# Technical Bulletin C320BEE

**Product:** *Integrated Amplifier*  
**Hardware Technical Bulletin:** *H2004-01*

**Subject:** NOISE IN UNIT

**Figure 1**

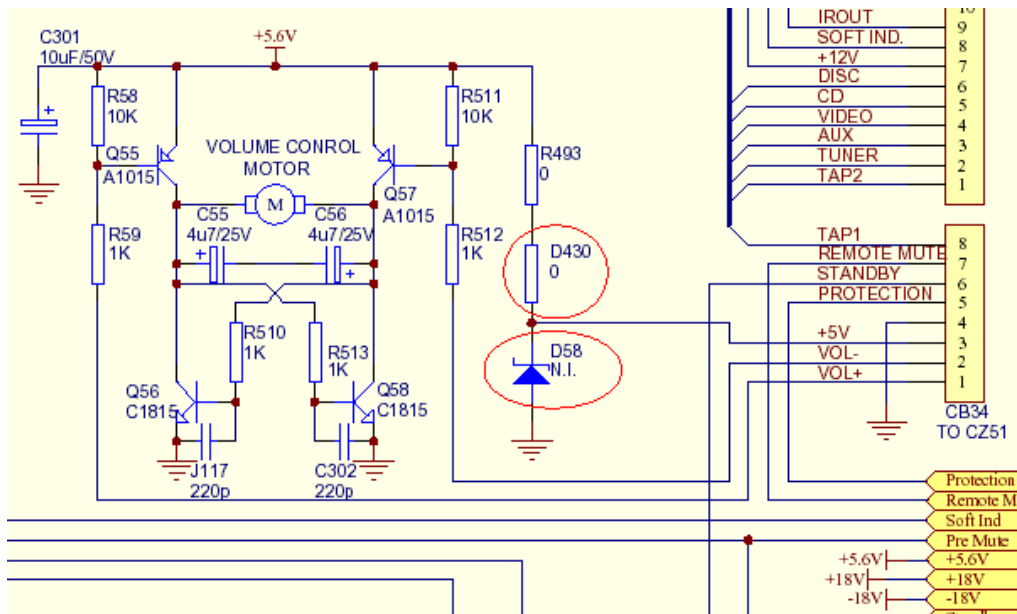
- 1) On the main pc board shown in figure 3, the diode D430 change from 1N4001, to a jumper link. Remove the zener diode D58 5v6 0.5W. See figure 1 for schematic change.*
- 2) On the power supply board shown in figure 4 remove D429 and install a jumper link in it's place. See figure 2 for the schematic change.*

**Figure 3**

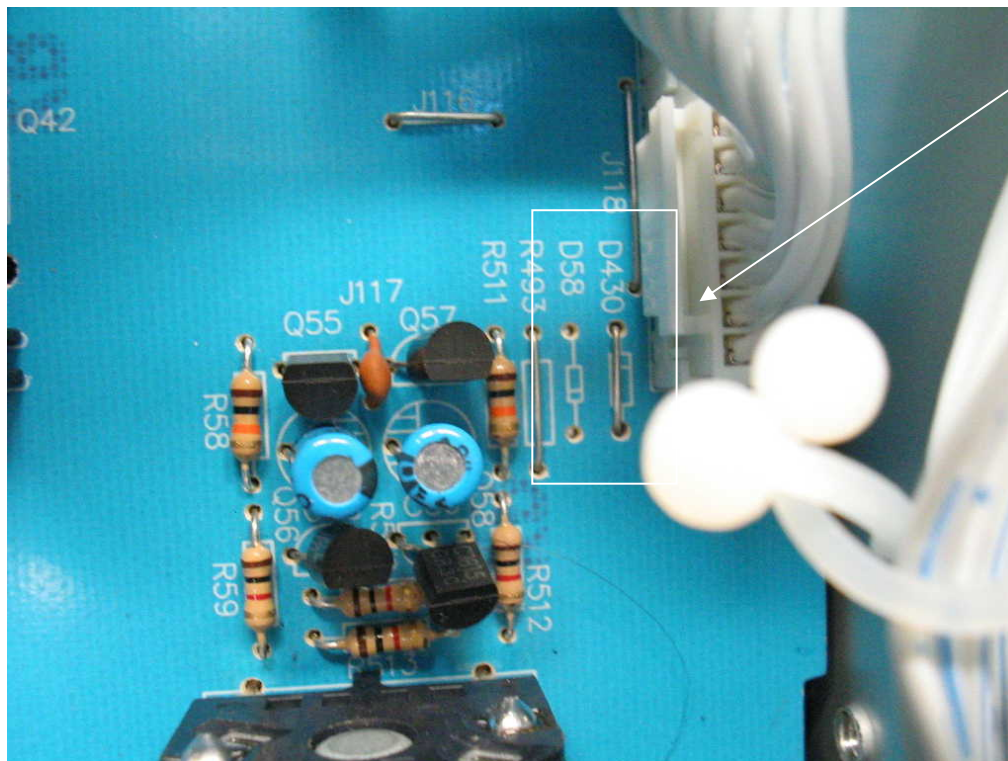
**D430 , REMOVE  
 AND INSTALL  
 JUMPER  
 D58, REMOVE**

**Figure 4**

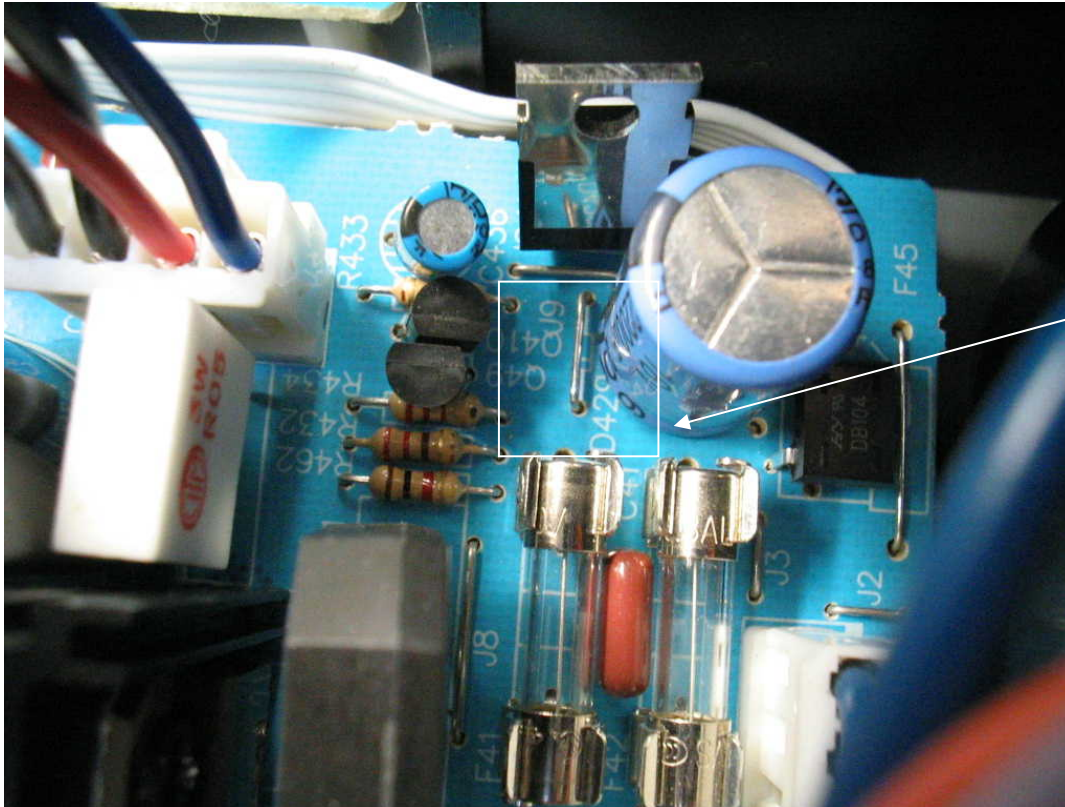
**D429 , REMOVE  
AND INSTALL  
JUMPER**
